## Access Compliance Report Public Rights-of-Way (Curb Ramps)

Intersection ID: 47016 Main Street: TRIBUNE\_DR Cross Street: GLAZER\_VALLEY\_CT Location: N

ADA ID: 81832958FADD Ramp Type: PerpDiag Initial Pass/Fail: Fail Overall Compliance: No Severity Score: 28.75

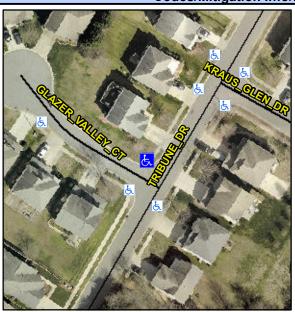
Not Found, R304.2.2, R304.5.3, R302.7

Compliance Description Data Compliance Description Data 45.5 No N/A Ramp Length (in) Ramp Slope (%) 9.1 No Ramp XSlope (%) Yes Ramp Width (in) 48.0 3.1 N/A N/A Flare Type LT N/A Flare Type RT N/A N/A N/A N/A Flare Slope RT (%) N/A Flare Slope LT (%) N/A Flare Traversable LT? N/A N/A Flare Traversable RT? N/A N/A Landing Length (in) N/A N/A DWS Provided? N/A N/A Landing Width (in) N/A N/A **DWS Contrast?** N/A N/A N/A N/A Landing Slope (%) DWS Length (in) N/A N/A Landing X Slope (%) N/A N/A DWS Full Width? N/A N/A Landing Curb? (Y/N) N/A N/A DWS Offset (in) N/A N/A N/A Shared Landing? N/A **Gutter Ponding?** N/A N/A Gutter Slope (%) N/A N/A Gutter Lip Ht (in) N/A N/A Gutter X Slope (%) N/A N/A Painted X Walk1? No N/A Painted X Walk2? No X Walk 1 Direction To SW X Walk 2 Direction To SE N/A N/A X Walk 1 Width (in) X Walk 2 Width (in) N/A X Walk 1 Slope (%) 5.8 X Walk 2 Slope (%) 0.9 X Walk 1 X Slope (%) 1.1 X Walk 2 X Slope (%) 5.9 N/A N/A N/A Ramp inside XWalk2? N/A Ramp inside XWalk1? Road Slope (%) 2.8 N/A Clear Space? N/A N/A Road X Slope (%) 6.9 Clear Space to XWalk (in) N/A N/A N/A N/A Any Obstructions? Storm Grate/Utility Hazard? N/A **Obstruction Type** Storm Grate/Utility Type N/A N/A

Poor

Remove & Replace Curb Ramp With Two New Directional Ramps or Equivalent.
